Subject: DA2023/0160 - 36 Rednal Street Mona Vale - Submission Gray

RE: DA 2023/0160

Lot 265 DP 752046 and Lot 24 DP 7953 - 36 Rednal Street Mona Vale NSW 2103

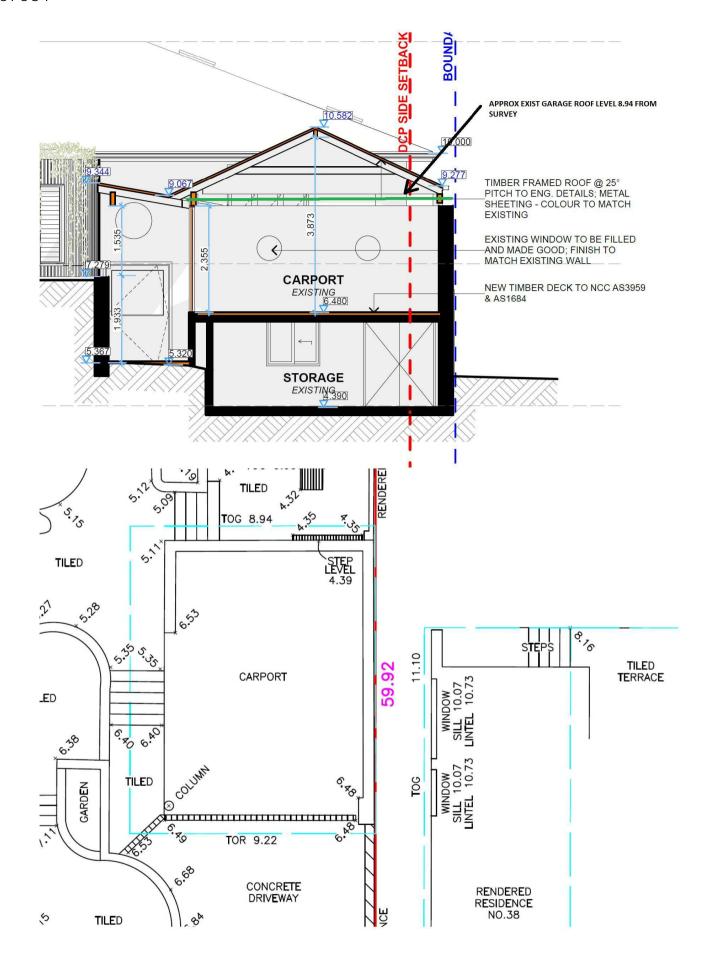
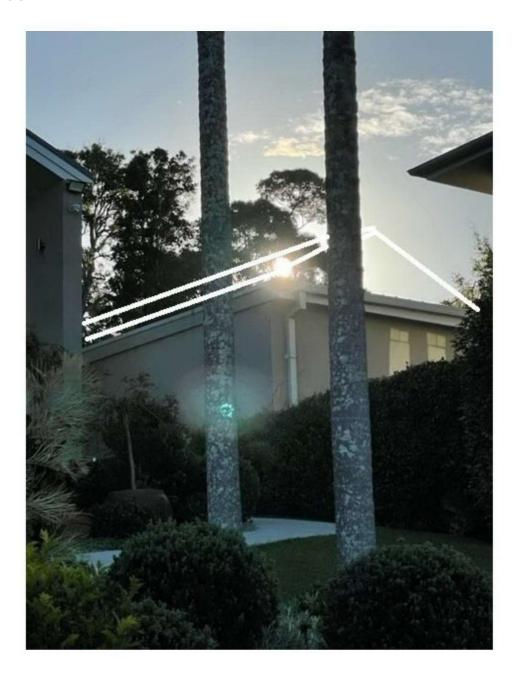
• Increased Overshadowing

Although some shadow diagrams are presented in the DA submission we consider that the proposal to introduce a pitched roof to the garage will increase overshadowing to 38 Rednal in the late afternoon. As a result the slope and extent of the proposed roof pitch to the garage has been raised with the proponent. At present we are working with our neighbours on this. The proposal at present is to erect a frame to indicate the proposed roof extent for consideration. We would maintain that as a minimum the roof pitch of the garage could be changed to match that of the main residence and that overhang north be minimised (refer attached sketches).

It is also noted and has been communicated to the applicant that with the introduction of the pitched roof to the garage there will be the need for an eaves gutter and its subsequent maintenance. We note that this eaves gutter has been located within 36 Rednal property, however we note that the only way to maintain this will be from the roof. This is again a reason to minimise the pitch of this roof to enable access.

- 1. Reconsideration of the garage roof pitch to minimise the impact of loss of solar access to 38 Rednal Street.
- 2. Confirmation of stormwater discharge location.
